# Corridor 51-204

Butte to Helena Corridor

Figure 1. Corridor 51-204

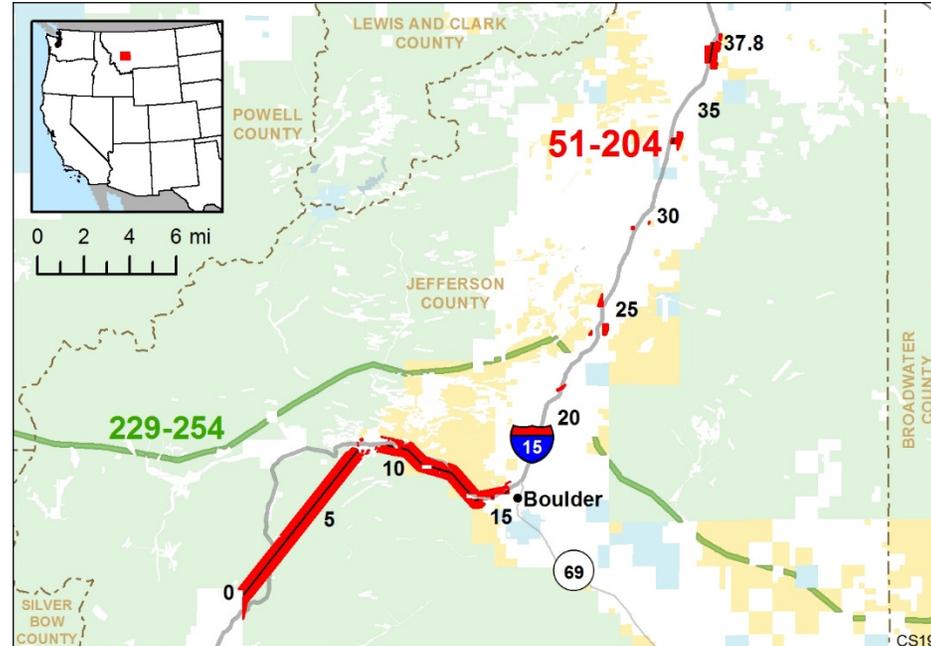
<b>CORRIDOR 51-204 REVIEW</b>			
<b>POTENTIAL COMPATIBILITY ISSUES or CONCERNS TO EXAMINE</b>	<b>MILEPOST (MP)<sup>1</sup></b>	<b>STAKEHOLDER INPUT and OTHER RELEVANT INFORMATION</b>	<b>POTENTIAL RESOLUTIONS BASED ON SITING PRINCIPLE ANALYSIS<sup>2</sup></b>
<i>USFS Jurisdiction: Beaverhead-Deerlodge National Forest</i>			
<i>Agency Land Use Plan: Beaverhead-Deerlodge NF LMP (2009)</i>			
SIO High and the corridor intersect - Management of areas under the High SIO designation provides for deviations from existing conditions but must repeat the form, line, color, texture, and pattern common to the landscape character so completely and at such scale that they are not evident. (Corresponds to a VQO of Retention.)	MP 0 to MP 3, MP 7 to MP 9, and MP 14	Transmission lines are within the corridor from MP 0 to MP 9 and I-15 is within the corridor from MP 9 to MP 14.	The corridor appears to best meet the siting principles as it is collocated with transmission lines or I-15. Due to the width of the High SIO designated area at MP 0 to MP 2, there is no ready option within the corridor for future infrastructure to avoid it. There is room within the corridor for future infrastructure to potentially avoid the High SIO area at other locations where it and the corridor intersect. There is also the potential to shift the corridor to the north at MP 14 to avoid the High SIO (locate within a VRM Class III area).

SIO Moderate and the corridor intersect – Management of areas under the Moderate SIO designation requires that deviations from existing conditions must remain visually subordinate to the landscape character being viewed. (Corresponds to a VQO of Partial Retention.)	MP 2 to MP 10 and MP 12 to MP 13	Transmission lines are within the corridor from MP 0 to MP 9 and I-15 is within the corridor from MP 9 to MP 14.	The corridor appears to best meet the siting principles as it is collocated with transmission lines or I-15. Due to the width of the Moderate SIO designated area at MP 2 to MP 10, there is no ready option within the corridor for future infrastructure to avoid it. There is room within the corridor for future infrastructure to potentially avoid the Moderate SIO area at MP 12 to MP 13 or to shift the corridor to the north (locate within a VRM Class III area).
<i>BLM Jurisdiction: Butte Field Office</i>

<i>Agency Land Use Plan: Butte RMP (2009)</i>			
Elkhorn Mountains ACEC and the corridor intersect - The ACEC is open to new ROWs (with some exceptions). The ACEC was designated for important cultural/historic sites, diverse upland	MP 24 and MP 37 to MP 38	At MP 24, I-15 and a gas pipeline are within the corridor and two transmission lines are west of the corridor; at MP 37 to MP 38 all of	The corridor is collocated with transmission lines or I-15 along its length. Although the ACEC is open to new ROWs, the Agencies could consider following the existing 100 kV transmission lines north at MP 9 to avoid the ACEC. This

<b>POTENTIAL COMPATIBILITY ISSUES or CONCERNS TO EXAMINE</b>	<b>MILEPOST (MP)<sup>1</sup></b>	<b>STAKEHOLDER INPUT and OTHER RELEVANT INFORMATION</b>	<b>POTENTIAL RESOLUTIONS BASED ON SITING PRINCIPLE ANALYSIS<sup>2</sup></b>
<p>and aquatic habitat for wildlife and fish, and unique National management area.</p> <p>The WVEC ROD amended the 1984 Headwaters RMP. Decisions from that ROD are carried forward in the Butte RMP. Multimodal corridors identified in the WVEC ROD (including Corridor 51-204) represent preferred locations on BLM lands for future electric transmission lines and oil, gas, and hydrogen pipelines.</p>		<p>these infrastructures are within the corridor.</p> <p>Comment on abstract: avoid the ACEC as it would be consistent with the BLM’s emphasis on managing the area as an ecological unit for the purpose of sustaining biological diversity and ecosystem processes.</p> <p>Comment on abstract: Elkhorn Mountains ACEC overlaps 292 acres of corridor.</p>	<p>may also provide a better connection to Corridor 229-254 by continuing northerly instead of following the interstate. The Agencies could also consider narrowing the corridor to 1,000 ft.</p>

- Rather than follow the highway (Interstate 15) ROW through the Beaverhead-Deerlodge NF, propose to cross through a section of the forest. An option should be considered that includes routing the corridor along Interstate 15. Recommend a more thorough and field level evaluation of this route for potential fish and wildlife concerns (comment on abstract).
- MP 16 to MP 37 should be considered a high conflict area for DEQ siting purposes. It is too fragmented to be effectively considered under Montana MFSA Preferred Location Criteria (comment on abstract).

*Analysis:* Existing IOPs and BMPs would be required. The Agencies could consider narrowing the corridor to 1,000 ft and realigning with existing infrastructure (pipeline and transmission line). In addition, the Agencies could consider an IOP for habitat connectivity so that transmission projects within Section 368 energy corridors are sited and designed in a manner that minimizes impacts on habitat connectivity.
